MEMORANDUM

SUBJECT: Compark Village South Major Amendment-Belford Ave and Bridge (SP21-028)

Compark Village South Major Amendment [Planning Case No. SP21-028]

(Revision to sheet LB-10 of the approved plans)

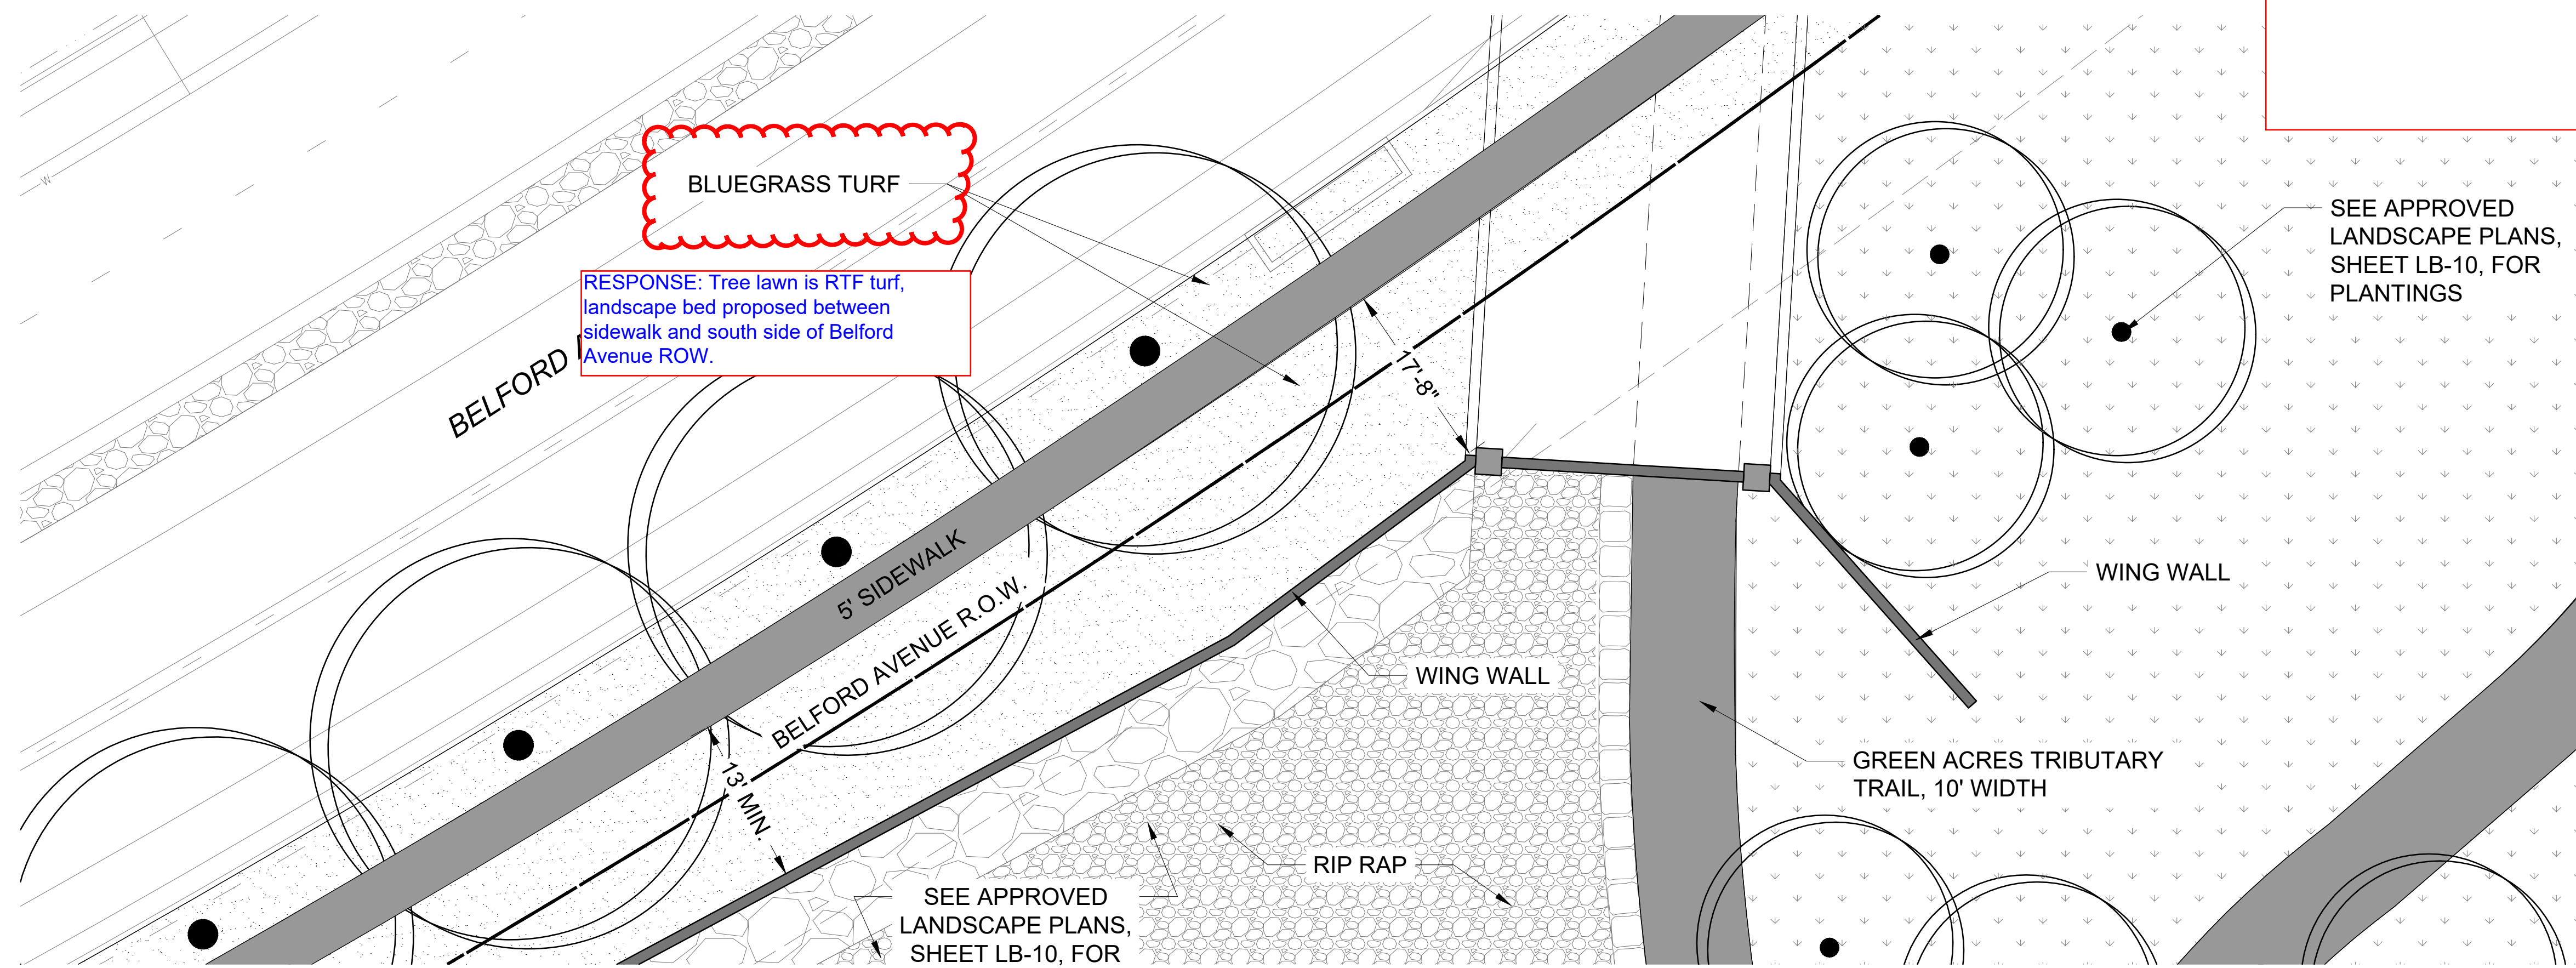
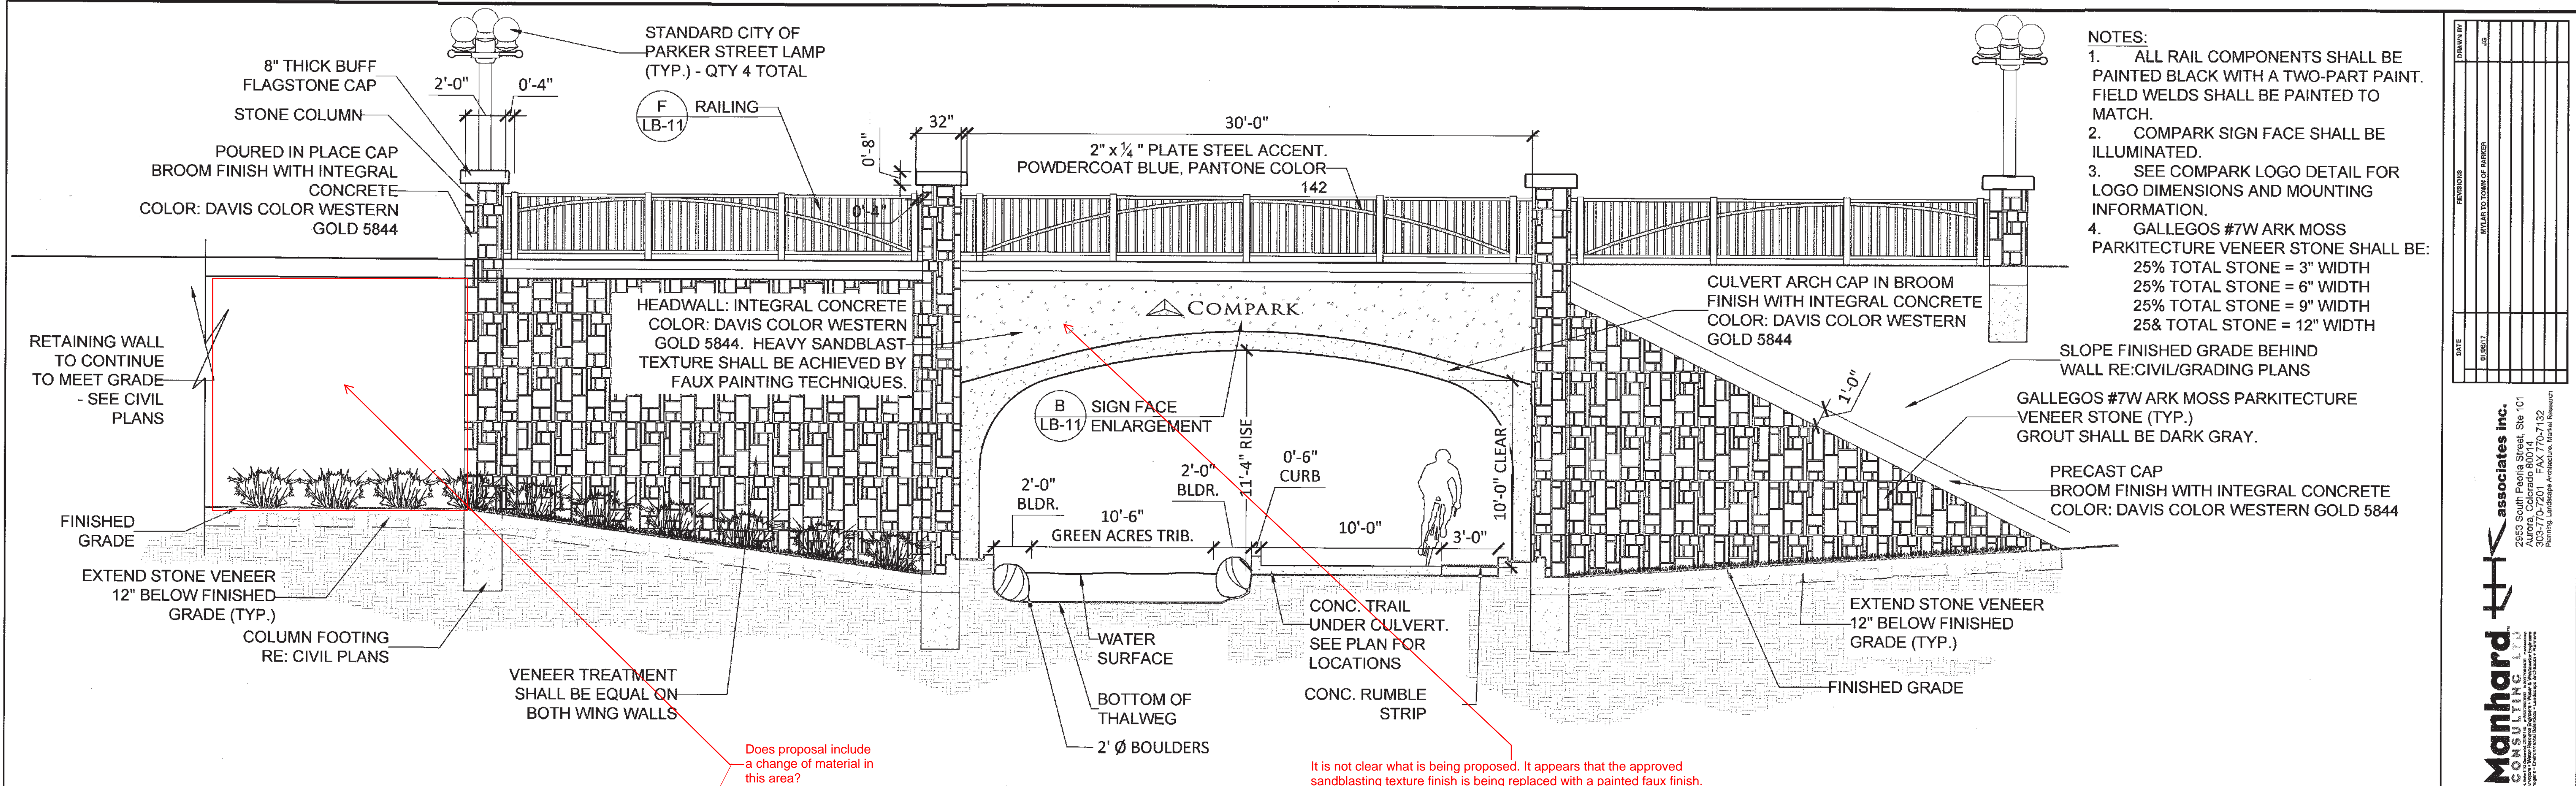
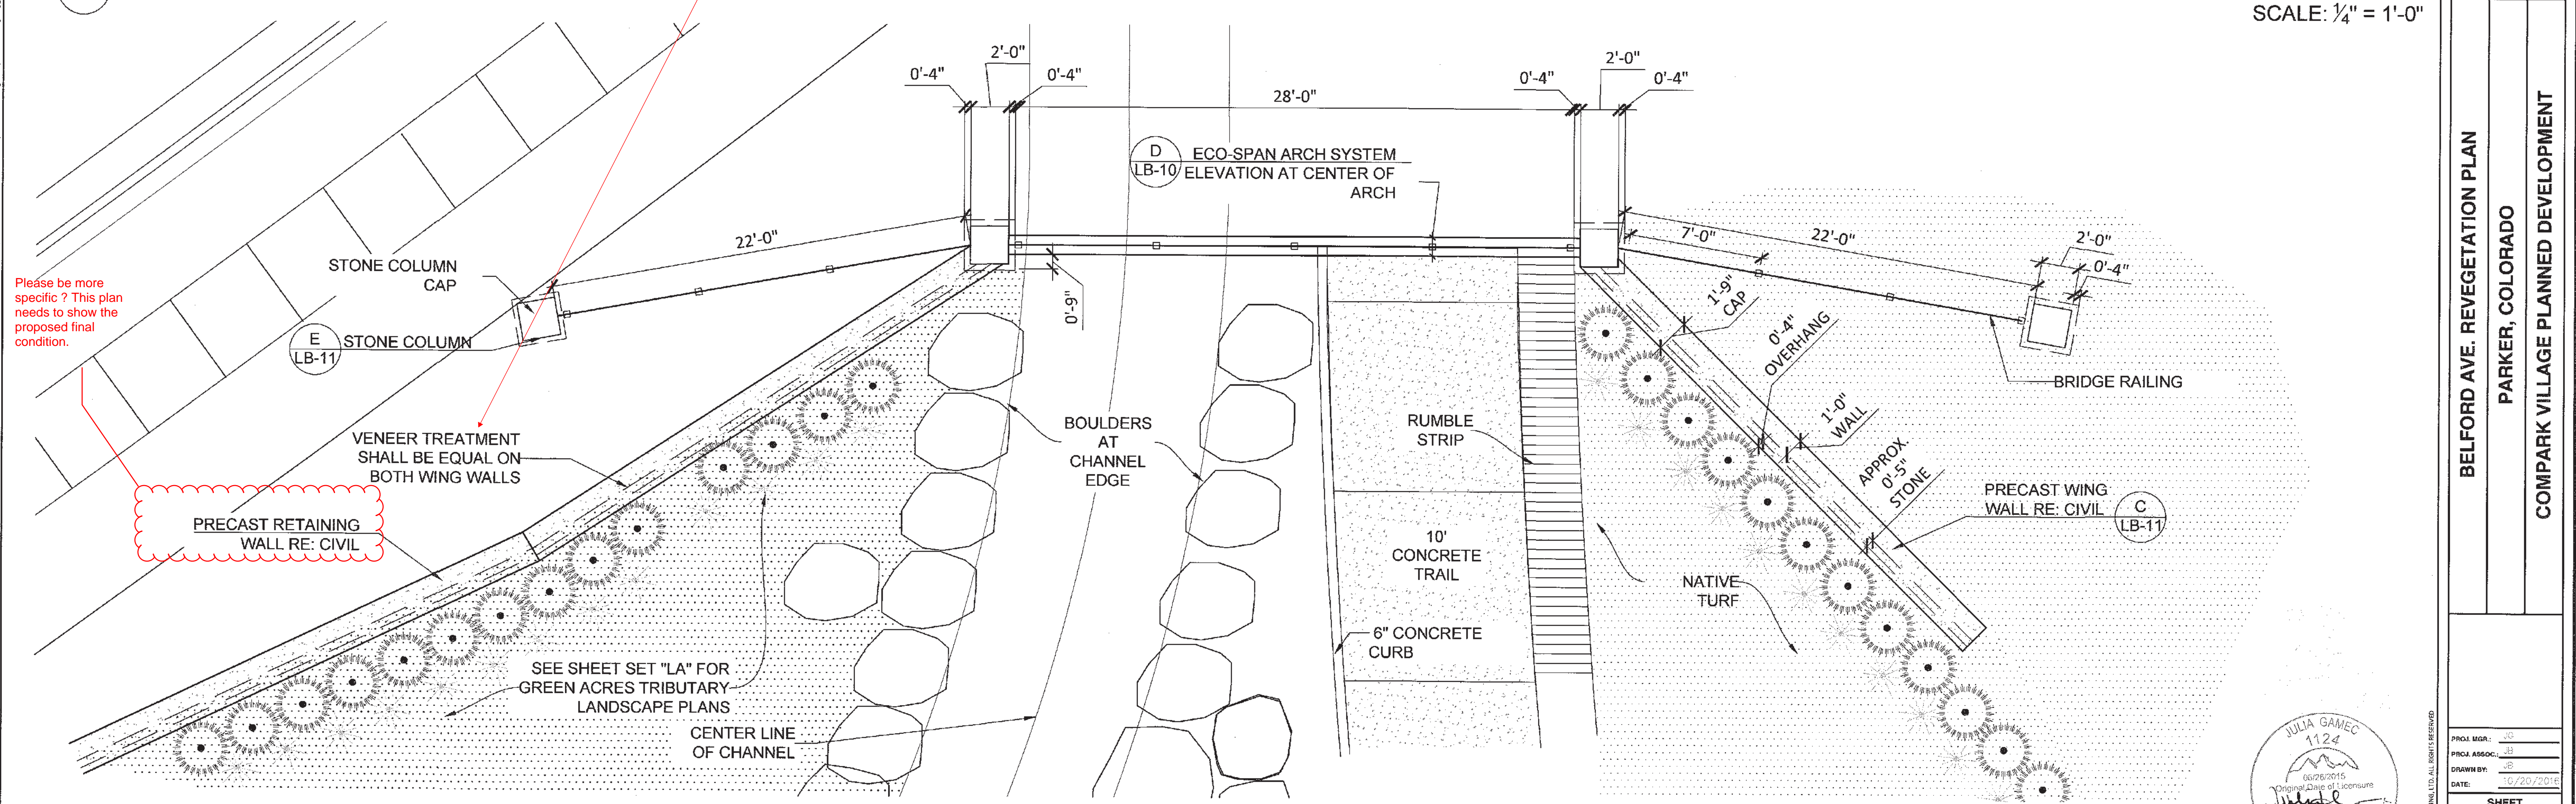
- 3. The narrative mentions changes to the retaining walls and refers to civil plans. Please elaborate within the narrative and clarify what and where these changes are being proposed with next submittal. Review of this aspect of the proposal may include additional comments following the provision of information and clarity. Please see redline of Green Acres Tributary LS, sheet LB10.

Please bubble all proposed changes on these plans.

Response: Retaining walls referenced in the Narrative are the Green Acres Tributary underpass culvert wing walls. The Belford Streetscape plans do not have any retaining walls located within the Belford Avenue ROW.

RESPONSE: Form liner and color updated to _____.

Belford Avenue Streetscape Project Limits

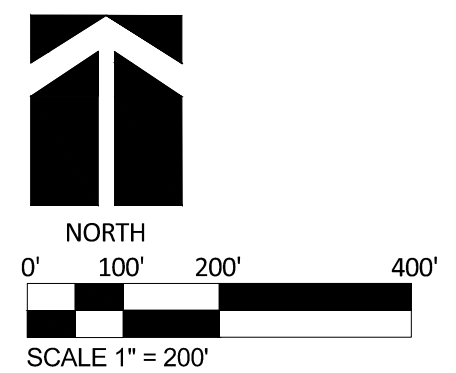
Narrative indicates proposal includes areas with approved retaining walls. Are changes to the retaining walls included in this proposal?

If so;

this is not mentioned here in the approved/proposed programs retaining walls are not clearly depicted in the submitted document locations of retaining walls are not shown changes to them are not clearly explained no detail has been provided.

Plans reference civil plans for areas with proposed changes. If civil plans are referenced they should be included in the submittal

RESPONSE: Retaining walls referenced in the Narrative are the Green Acres Tributary underpass culvert wing walls. The Belford Streetscape plans do not have any retaining walls located within the Belford Avenue ROW.

Overall analysis of sheet 2 of 8

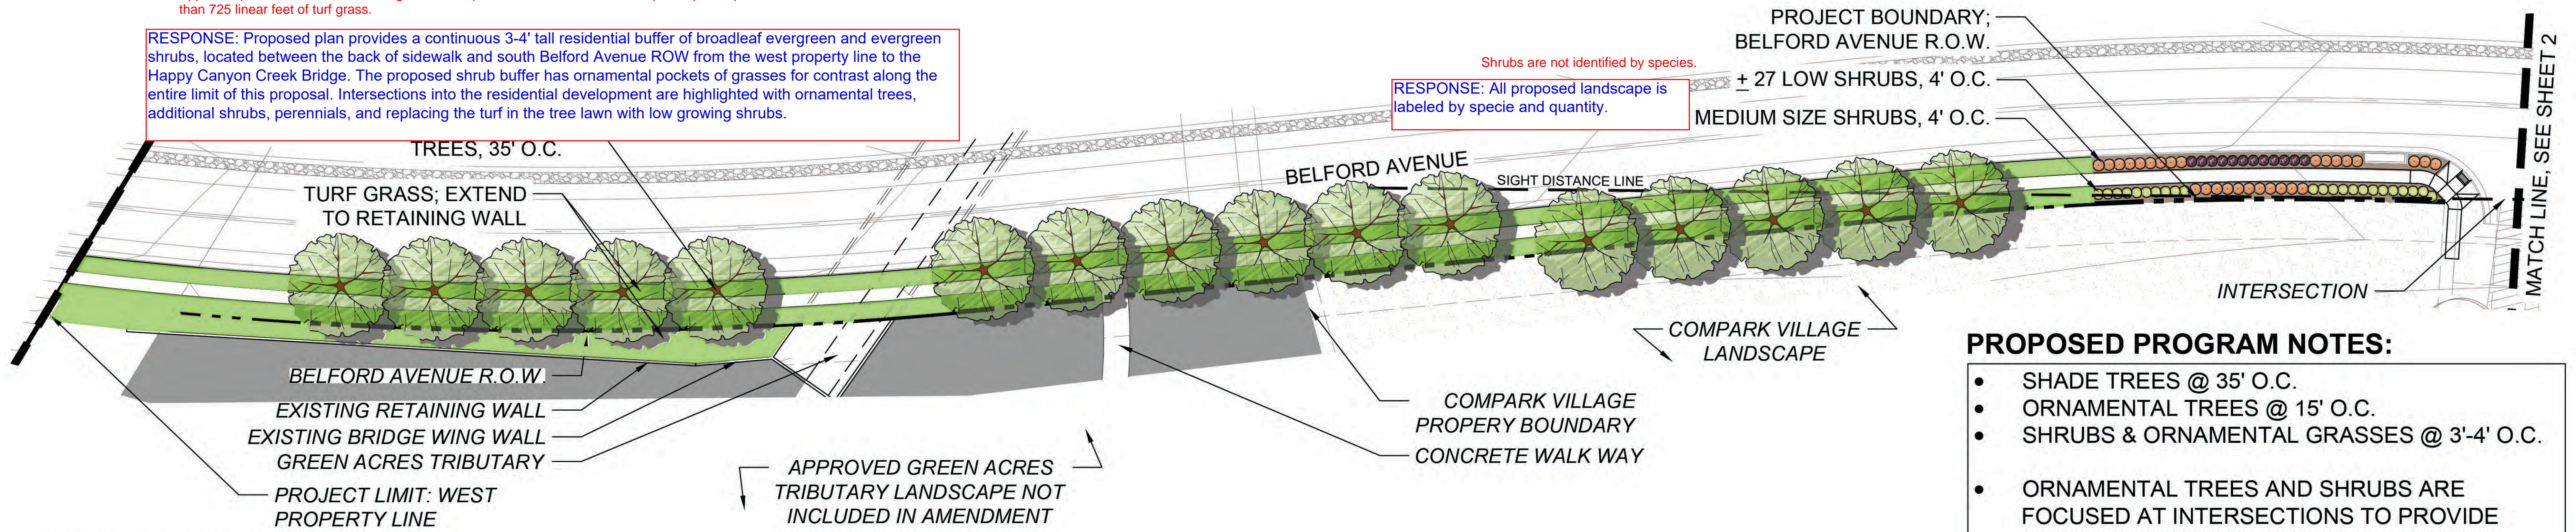
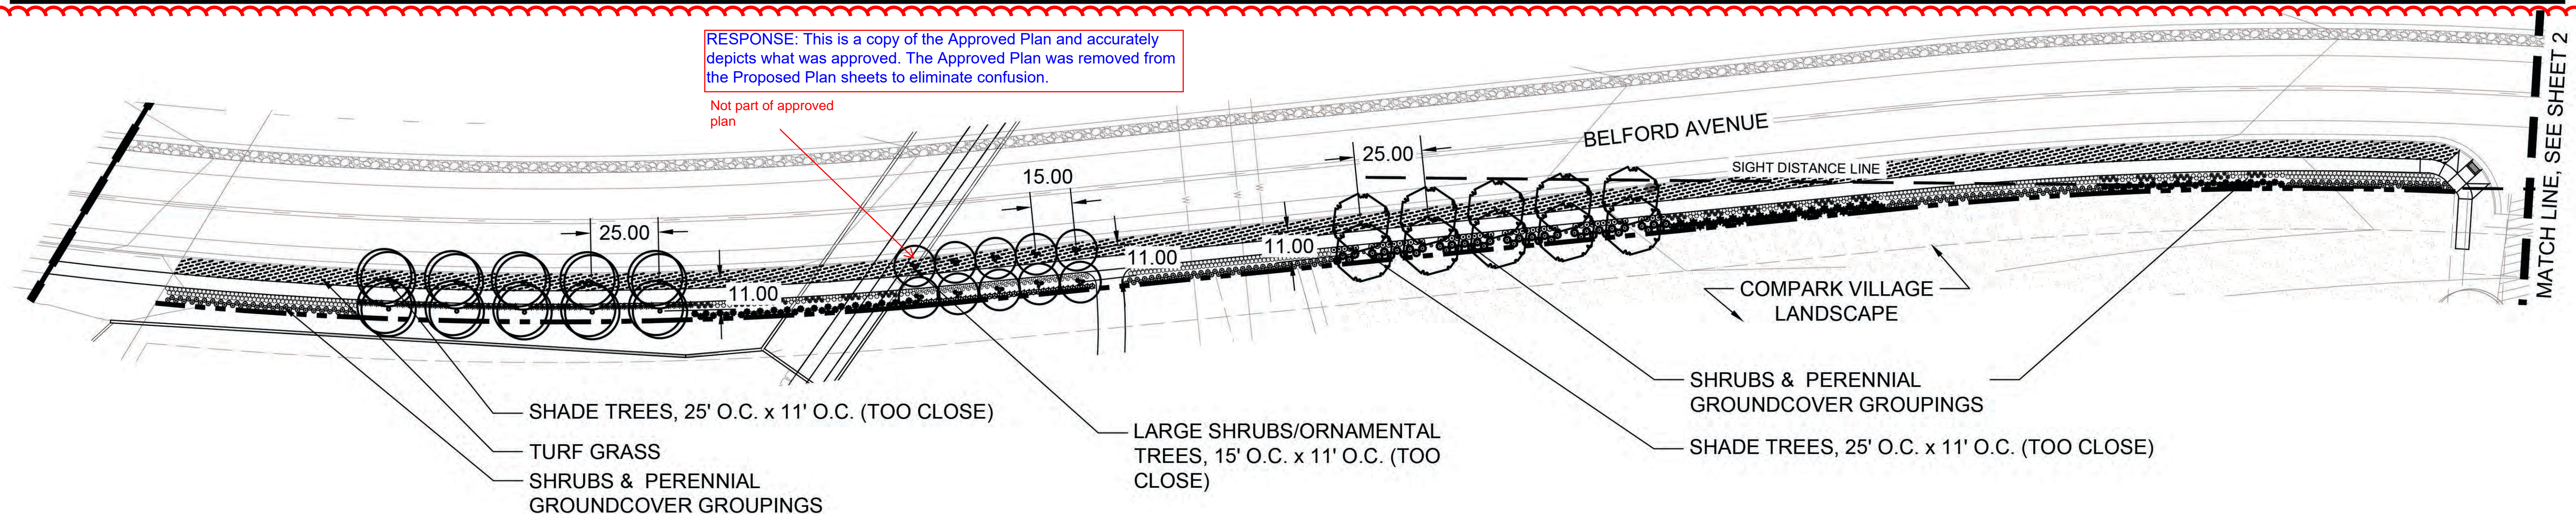
Aethstetics- Staff attempted to quantify thru analysis of the number, variety and design of plantings. Staff did not provide analysis of all sheets, using only sheet 2 of 8 for analysis.

The approved plan includes 29 trees in this area, including ornamental trees. The proposed amendment provides 11 shade trees in the same area. The shade tree varieties are not identified on the landscape plan and staff could not locate a plant list.

The approved plan includes 640+ shrubs, grasses and perennials in 14 varieties. Planter beds are arranged in a variety of 17 smaller sections ranging from 20’ to 180’ in an effort to break up the more than 725 linier feet in this area. The proposed plan replaces these beds with approx. 600 linier feet of turf 8 feet wide and approximately 125 linier feet of landscaped beds at the intersection with planter beds on both sides of the sidewalk.

Approved plan includes 29 trees including 9 ornamental in this section, proposed includes 11 shade trees. Shade trees are not identified.

Approved plan includes 648 shrubs, grasses and perennials in 14 varieties. Proposed plan replaces these beds with more than 725 linear feet of turf grass.

Shrubs are not identified by species.

Approved Landscape Plan does not include long swathes of the same variety as shown here. This is not a correct depiction of what is approved.

RESPONSE: Proposed plan provides a continuous 3'-4' tall residential buffer of broadleaf evergreen and evergreen shrubs, located between the back of sidewalk and south Belford Avenue ROW from the west property line to the Happy Canyon Creek Bridge. The proposed shrub buffer has ornamental pockets of grasses for contrast along the entire limit of this proposal. Intersections into the residential development are highlighted with ornamental trees, additional shrubs, perennials, and replacing the turf in the tree lawn with low growing shrubs.

RESPONSE: All proposed landscape is labeled by specie and quantity.

RESPONSE: This is a copy of the Approved Plan and accurately depicts what was approved. The Approved Plan was removed from the Proposed Plan sheets to eliminate confusion.

RESPONSE: This is a copy of the Approved Plan and accurately depicts what was approved. The Approved Plan was removed from the Proposed Plan sheets to eliminate confusion.
